CALVERT CLIFFS NUCLEAR POWER PLANT, UNIT NO. 1

AMENDMENT TO FACILITY OPERATING LICENSE

Amendment No. 185
License No. DPR-53

ATTACHMENT TO LICENSE AMENDMENTS

FIGURE 3.4.9-1

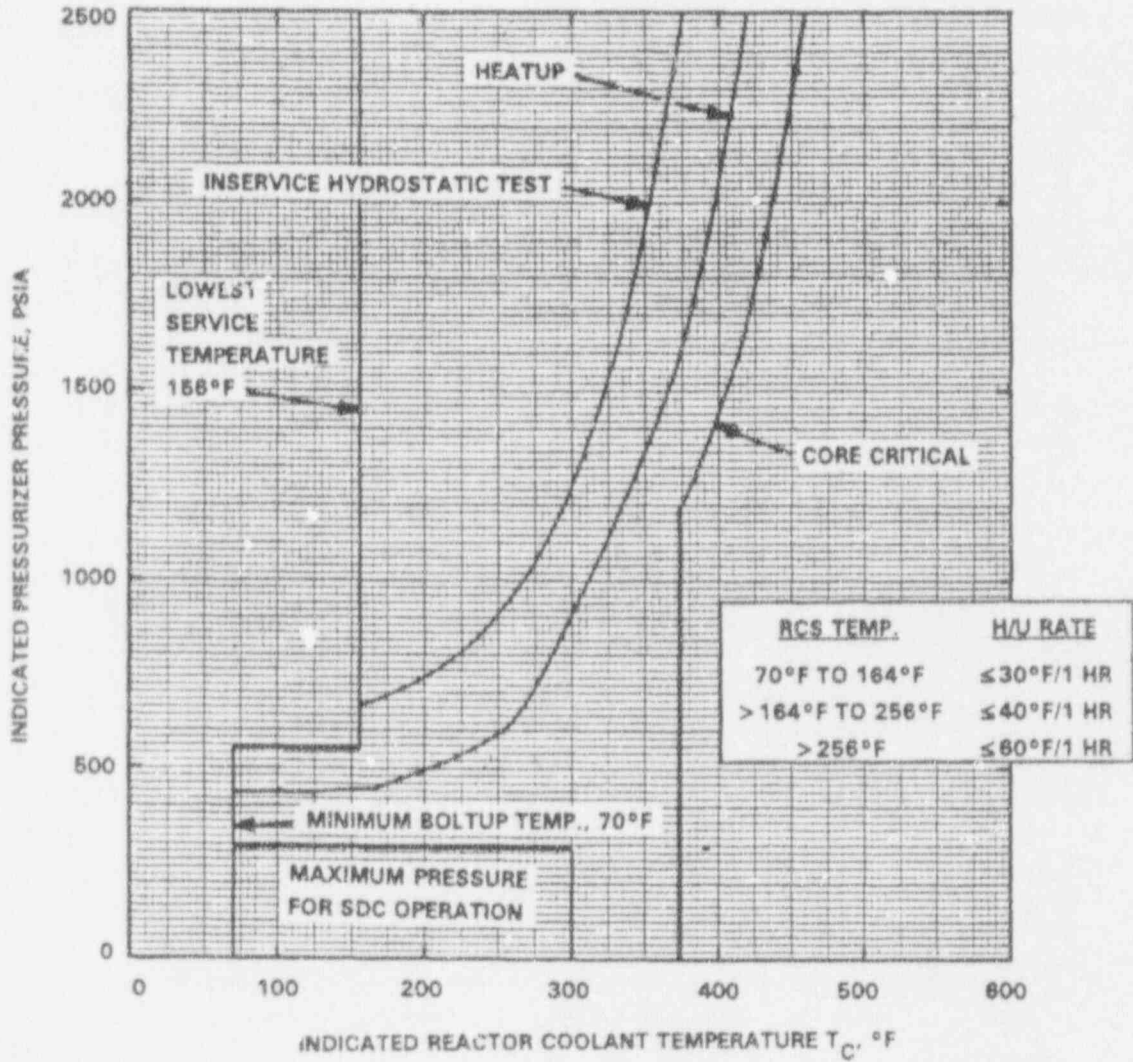
3.4.9.1 The Reactor Coolant System (except the pressurizer) temperature and pressure shall be limited in accordance with the limit lines shown on Figures 3.4.9-1 and 3.4.9-2 during heatup, cooldown, criticality, and inservice leak and hydrostatic testing with:

CALVERT CLIFFS UNIT 1 HEATUP CURVE, FOR FLUENCE $\leq 2.61 \times 10^{19}$ n/cm²
 REACTOR COOLANT SYSTEM PRESSURE TEMPERATURE LIMITS

FIGURE 3.4.9-2

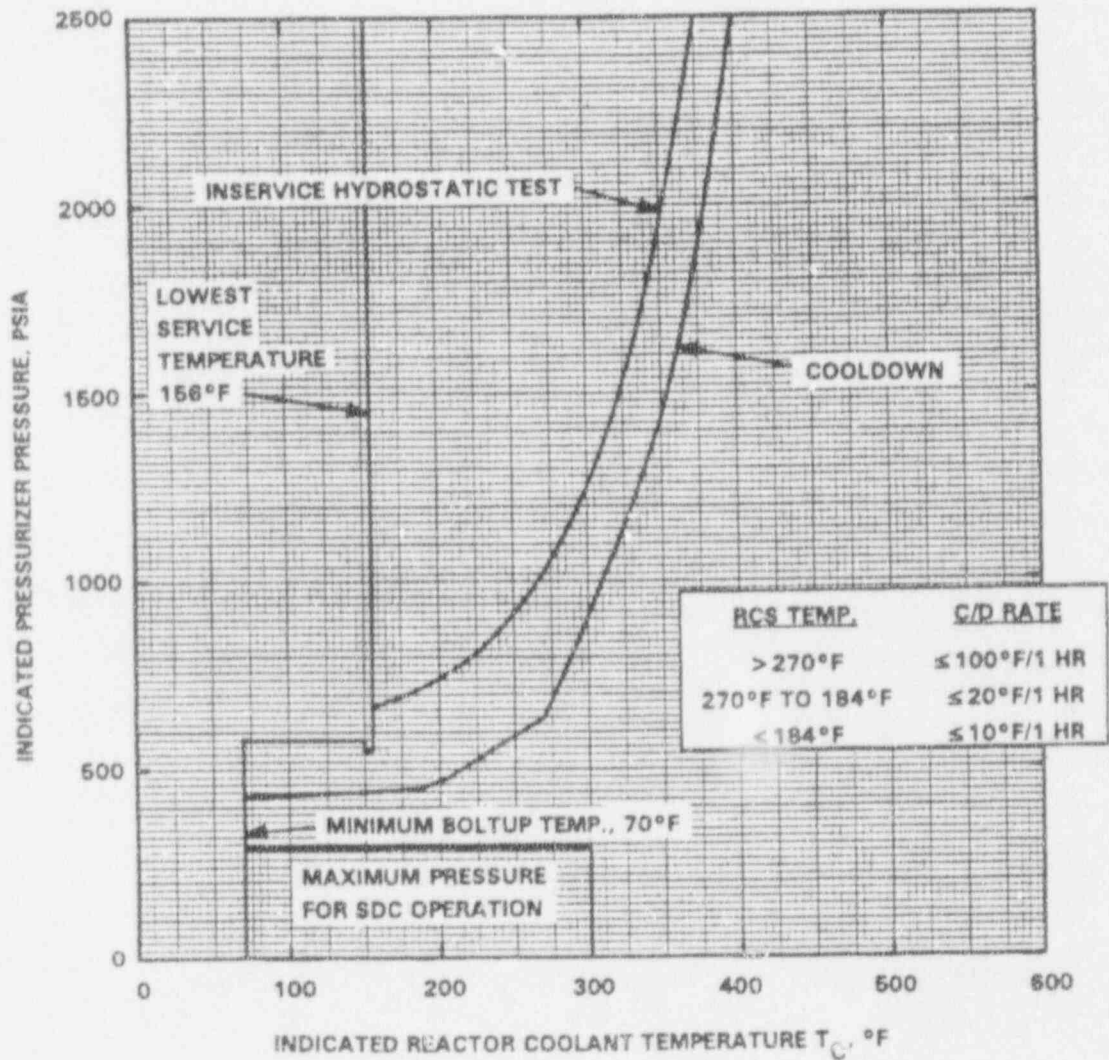
CALVERT CLIFFS UNIT 1 COOLDOWN CURVE, FOR FLUENCE $\leq 2.61 \times 10^{19}$ n/cm²
REACTOR COOLANT SYSTEM PRESSURE TEMPERATURE LIMITS

FIGURE 3.4.9-3

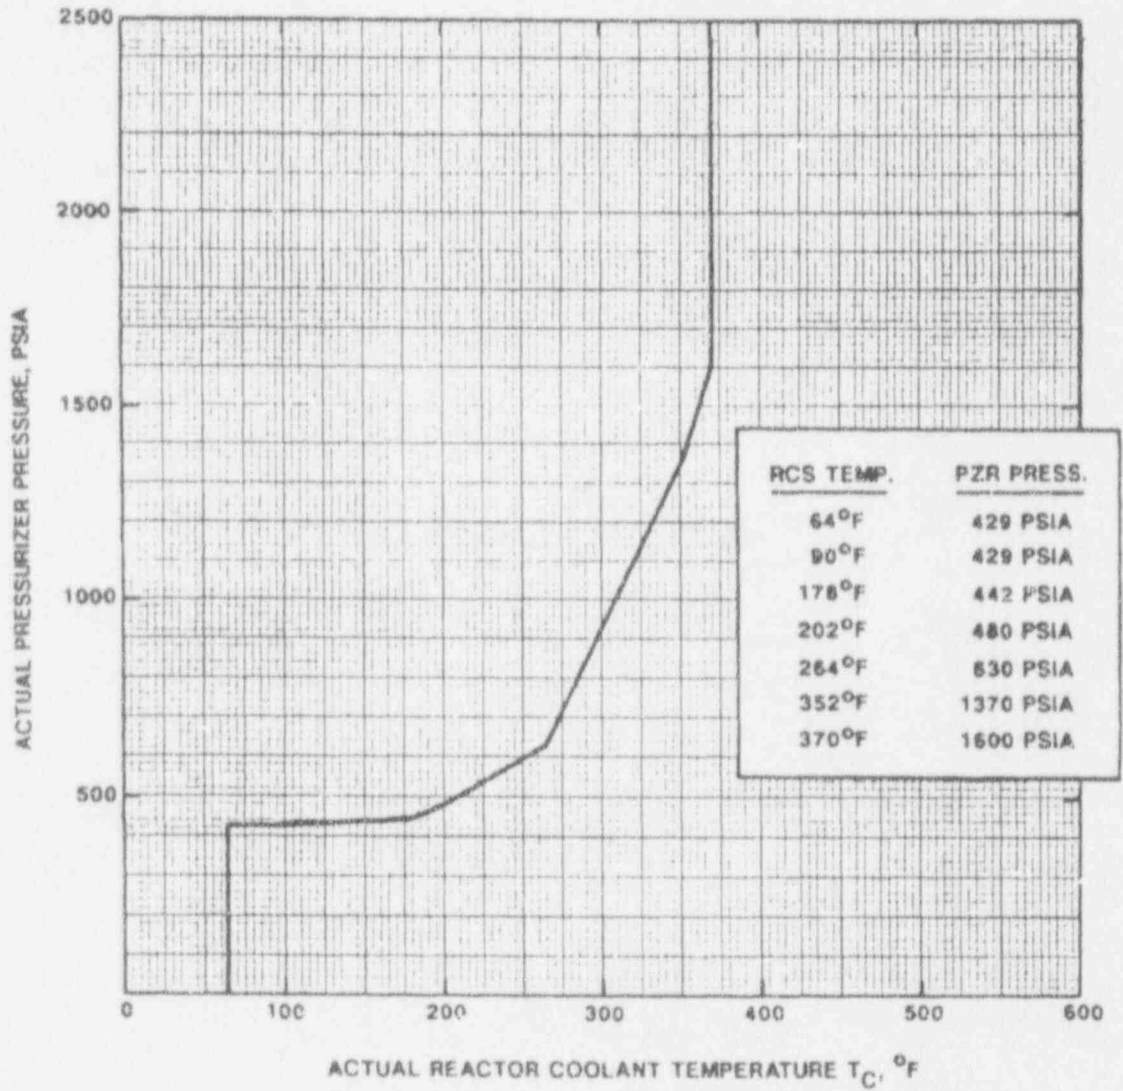
1. Two power-operated relief valves (PORVs) with a trip setpoint below the curve in Figure 3.4.9-3*, or
 2. A single PORV with a trip setpoint below the curve in Figure 3.4.9-3* and a Reactor Coolant System vent of ≥ 1.3 square inches, or

CALVERT CLIFFS UNIT 1, FOR FLUENCE $\leq 2.61 \times 10^{19}$ n/cm²
 MAXIMUM PORV OPENING PRESSURE vs TEMPERATURE

The PORV setpoint is chosen to protect the most limiting of the heatup or cooldown Appendix G limits. Figure 3.4.9-3 shows the maximum PORV opening pressure. This includes corrections for static and dynamic head, and pressure overshoot to account for PORV response time and the maximum pressurization rate. The actual PORV setpoint is controlled by procedure and accounts for device uncertainty, calibration uncertainty and loop drift.
